Subject: City of Vancouver Comments on the Draft EIS for I-5 Columbia River Crossing

City of Vancouver Comments on Columbia River Crossing DRAFT EIS					
CHAPTER	PAGE	SECTION	LINE	COMMENT		
SUMMARY						
	S-14	Alternative 4	Figure: Supplemental Crossing with BRT	Shows primary bike/ped pathway on only one side. There is a pathway on the other side too and PBAC recommended widening both sides if this option is chosen.		
	S-16	Alternative 5	Figure: Supplemental Crossing with LRT	Shows primary bike/ped pathway on only one side. There is a pathway on the other side too and PBAC recommended widening both sides if this option is chosen.		
	S-19	Multimodal River Crossing & Highway Improvements	Exhibit 16	Should show bike/ped pathway on Southbound downstream side of bridge not northbound structure.		
	S-21	Multimodal River Crossing & Highway Improvements	Exhibit 18	Shows primary bike/ped pathway on only one side. There is a pathway on the other side too and PBAC recommended widening both sides if this option is chosen.

Figure III-4: Project 3, Discovery Loop / Central City

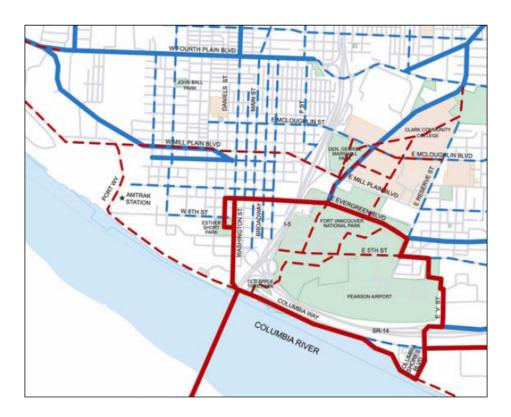
3-201 and following	3.7.2	Long-Term Effects	Does not include the Discovery Trail loop that crosses the APE on Evergreen Blvd. as well as along the Columbia. (See attached section of the 2004 VCPRD Paths & Trails Master Plan describing the trail and planned improvements. In addition, see information on the VCPRD website: http://www.cityofvancouver.us/parks-recreation/parks trails/trails/discovery loop.htm.)
	3-207	3.7.3	Long-Term Effects	This section should include analysis of the barrier effect of a wider freeway with more cars on it and high sound walls (10 to 18 feet) on the trail connections over it (Discovery Trail and the Seventh Street pedestrian bridge).
	3-207	3.7.3	Long-Term Effects, 1 st full paragraph	The Seventh Street pedestrian connection is very important to the urban trails network, and is included in planned pedestrian improvements in the Vancouver Comprehensive Plan. This connection should be included in the project and any alternative that precludes its development is inconsistent with City plans.
